PUBLIC INTEREST REVIEW FOR GROUNDWATER APPLICATIONS

TO: Water Rights Section Date 12/7/2015
 FROM: Groundwater Section Gerald H. Grondin (Darrick E. Boschmann)
Reviewer's Name
 SUBJECT: Application G- 18129 Supersedes review of N.A.
Date of Review(s)

A. GENERAL INFORMATION: Applicant's Name: Otley Brothers Inc. County: Harney

DETAILED REPORT ON THE WATER AVAILABILITY CALCULATION

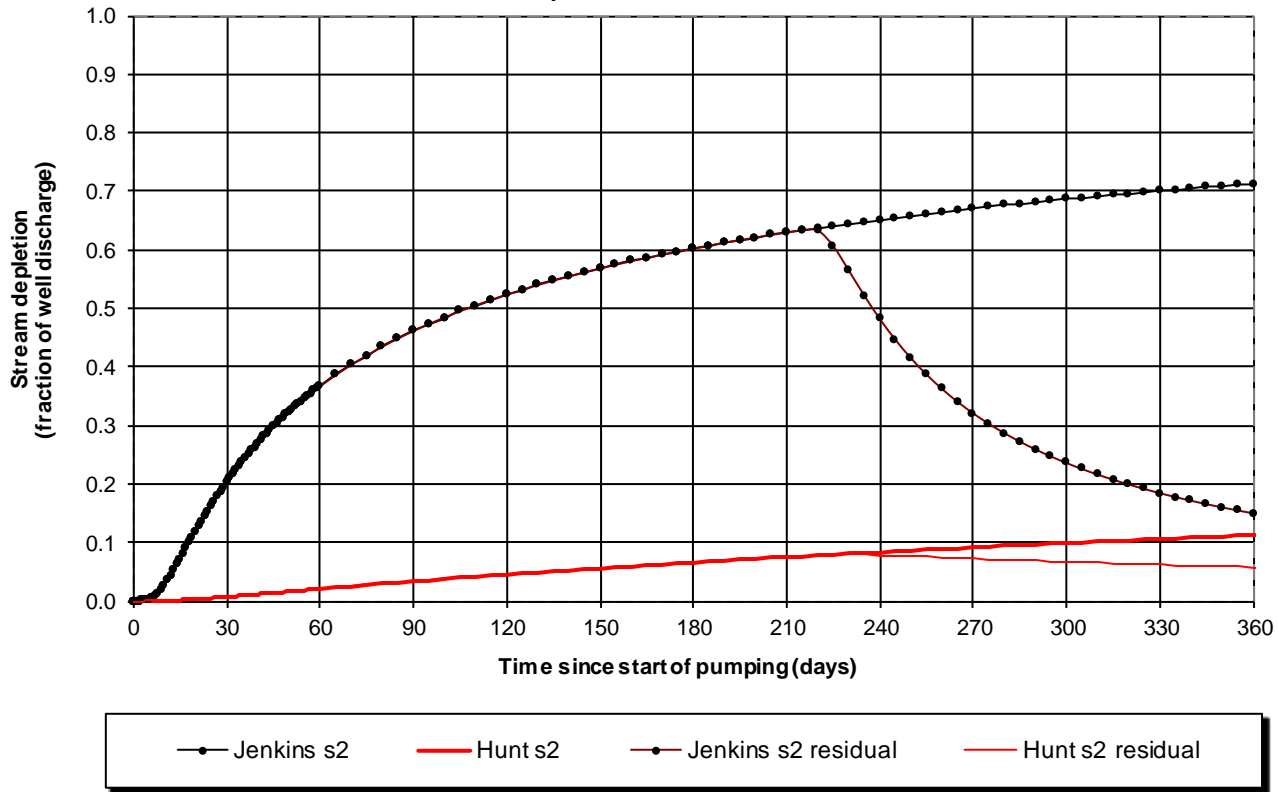
C4a. Hunt (1999) was used to calculate the interference between Well 5 and SW #1, the closest surface water body outside of a mile from the proposed wells. Very little data is available about aquifer parameters at this location. The values used for the calculation are conservative and appropriate until better values become available. The calculations used an intermediate transmissivity of 1000ft²/day. Additionally, the calculation used an assumed intermediate storage coefficient (0.001). The pumping rate used represents the maximum allowable duty prorated over the irrigation season (3.01 cfs). See reports attached.

Interference is determined to be less than 1% of the 80% flow in all months evaluated.

Greater Harney Valley Groundwater Level Trends Oregon Water Resources Department April 2015 Draft

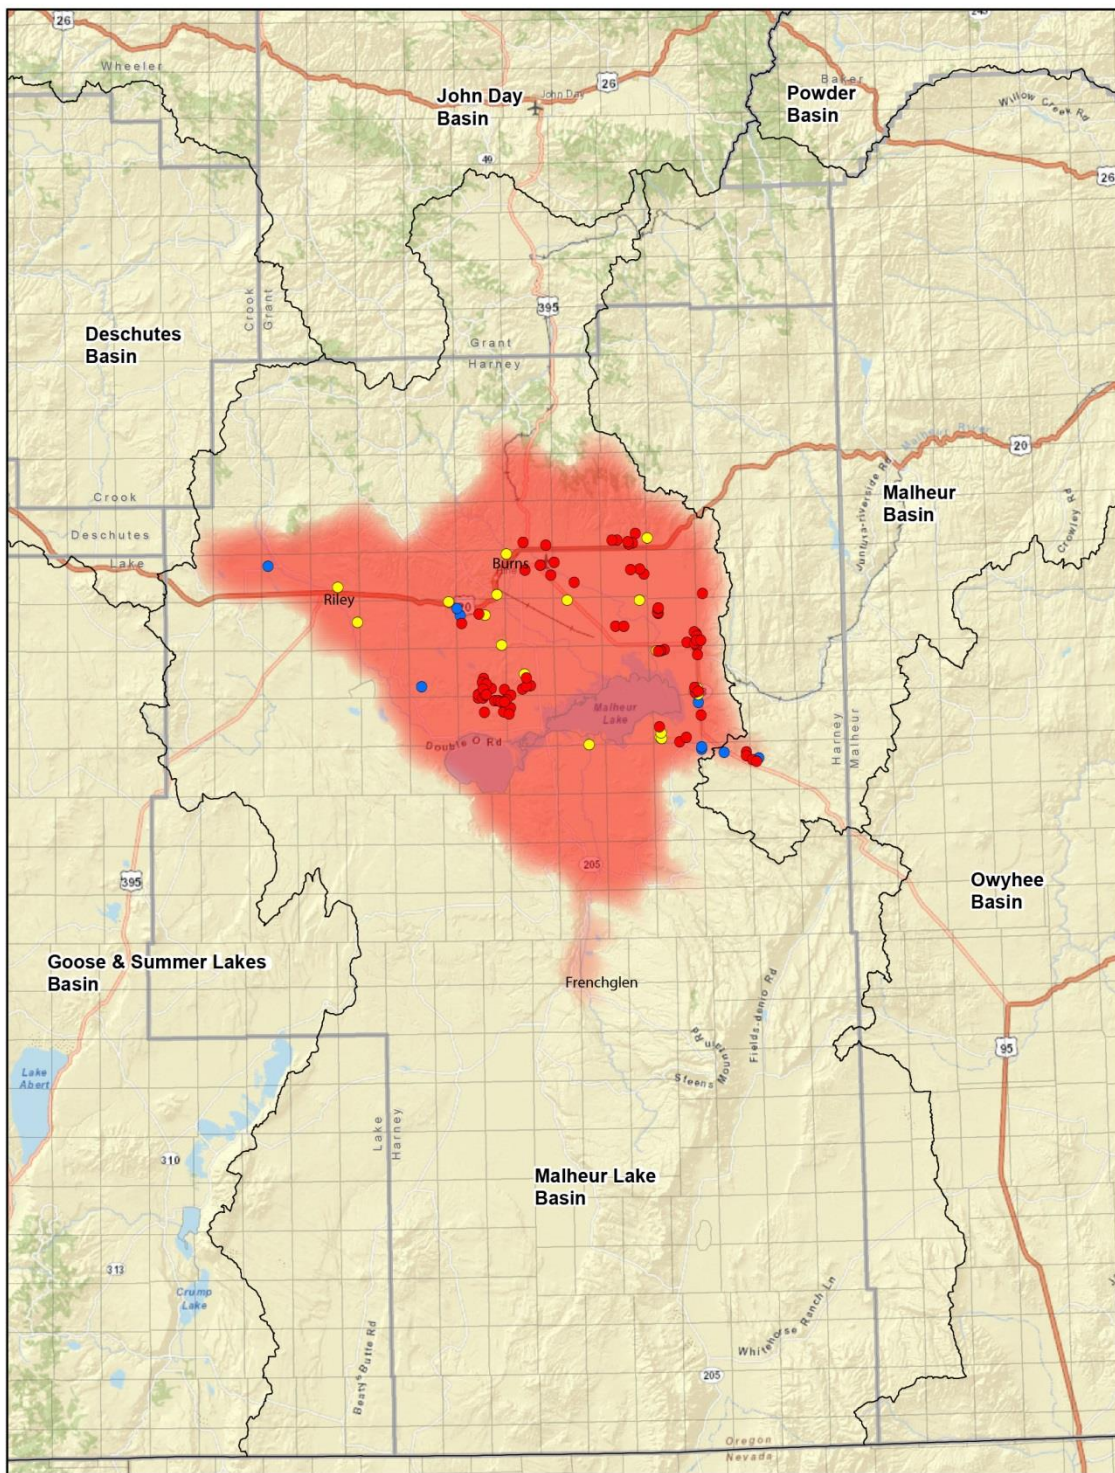
The proposed well(s) for this application is within the greater Harney Valley area where observed groundwater level declines are occurring in most areas (see attached map). The decline indicates that demand for groundwater is exceeding the average annual recharge. An analysis by the Department confirms the volume of groundwater permitted for annual use exceeds the average annual volume of recharge to groundwater. The Department also estimates that approximately 30 percent of the total acreage permitted for groundwater use has yet to be developed. Groundwater development for these acres under already-existing permits will further increase the groundwater level decline rate. Based on the location of the proposed POA(s), the Department finds that the proposed groundwater use will occur from the same groundwater source exhibiting groundwater level declines. Groundwater is therefore determined to be over-appropriated [see OAR 690-400-0010(11)(a)(B)] and the proposed use for this application is not within the capacity of the resource.

If a permit is issued, the following conditions are recommended:

7N: Annual Measurement and Decline Condition

The permittee shall construct one (1) minimum six-inch diameter observation well to penetrate the same aquifer as the production wells. The well shall meet the Department's minimum well construction standards and shall be cased and sealed to the same depth as the production wells. The well shall be constructed at a location approved by the Department for the purpose of instrumentation with continuous water-level monitoring equipment. The landowner or permittee shall provide access to Department staff to install and maintain the monitoring equipment. The well shall not be used for any other purpose while the Department is monitoring water levels. The well shall be completed prior to water use under the terms of any permit issued.
